E-Rate 29 (FY2026) Internal Connections Q & A – RFP 26-30 (Updated 1/13/26)

San Carlos Elementary

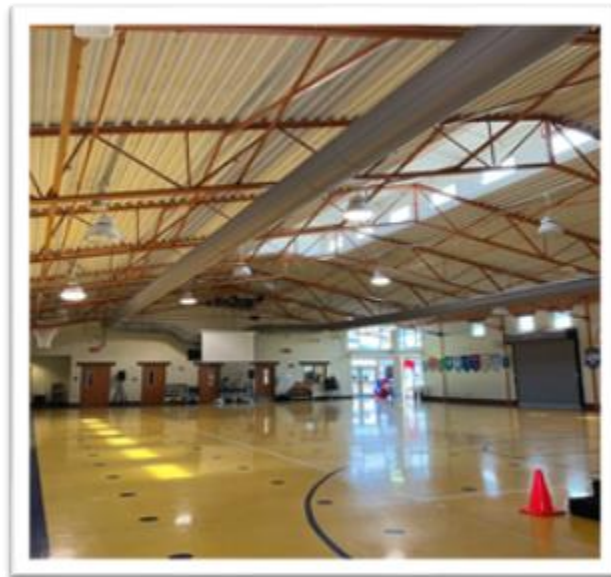
Question-13: Will any of the access points require a lift for installation? If so, how many campuses?
A: Yes, we have identified 3 campuses that will need a lift. San Carlos, Eisenhower, and Magee.

Magee

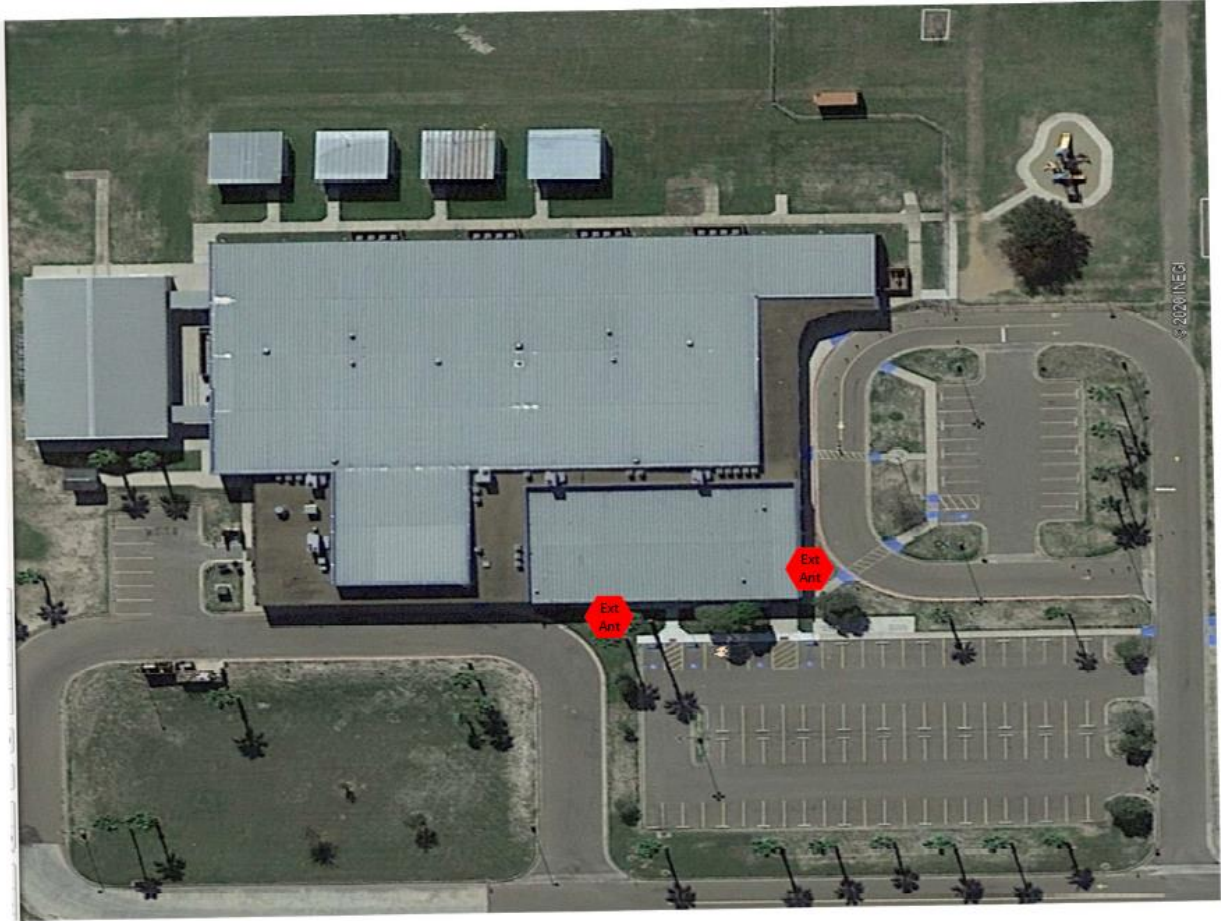
Question 14: Do you have AP placement maps for the access points being requested?
A: The Internal AP's will be replacing existing internal access points; classrooms, libraries, gymnasiums, cafeterias, and front office areas have internal AP's. External AP locations will be provided (see maps below).
